NUREG-1232
Vol. 2

Safety Evaluation Report

on Tennessee Valley Authority:
Sequoyah Nuclear Performance Plan

**U.S. Nuclear Regulatory
Commission**

Figure 1. MSIV Solenoid EQ Test Chamber Temperature

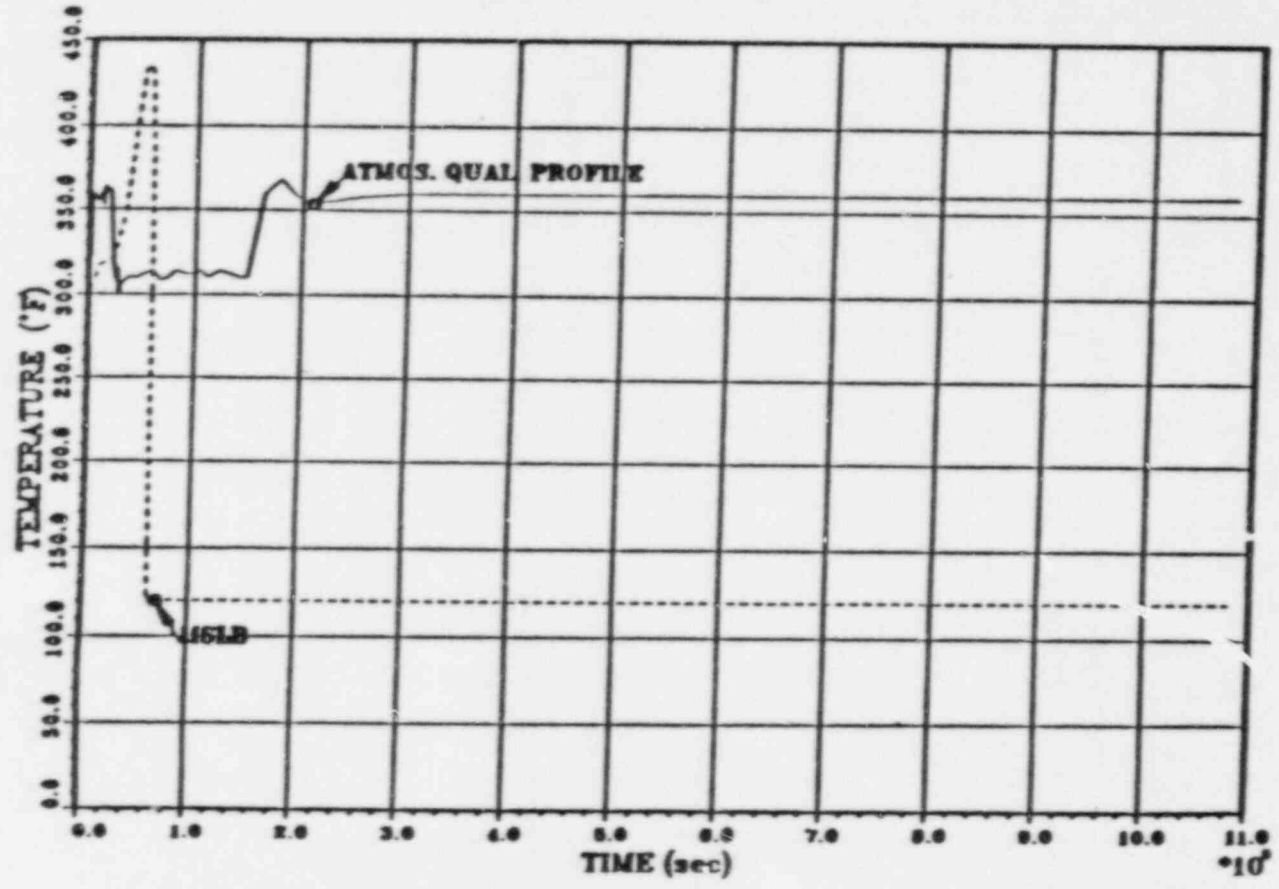
TVA also provided details of the guidelines used in constructing the heat transfer models. TVA's assumptions were made to conservatively increase the temperature predicted during a MSLB, while lowering the surface and internal temperatures resulting from analysis of EQ test chamber profiles. In this way, higher than expected surface and internal temperatures resulting from MSLBs are compared to lower than expected surface and internal temperatures derived from the qualification tests, thereby adding conservatism. The values of heat transfer coefficients used for the MSLB analyses were provided along with schematics of the models used. The Licensee concluded that qualification of the MSIV devices was established for each component by comparison of the calculated thermal response during a MSLB to the calculated response during qualification testing. The qualification for steam and moisture exposure is based wholly upon the existing qualification test results. The review of the existing qualification test results was not within the scope of this evaluation. The results of the existing qualification tests have been assumed to be acceptable during this evaluation. A sample of Licensee-supplied temperature profiles is included as Figures 1 through 3. Figure 1 represents the EQ temperature profile of a MSIV solenoid versus the MSLB temperature profile. Figure 2 is a plot of the calculated MSIV solenoid surface temperature during the MSLB. Figure 3 represents the calculated internal coil temperature during a MSLB as compared to the EQ test temperature.
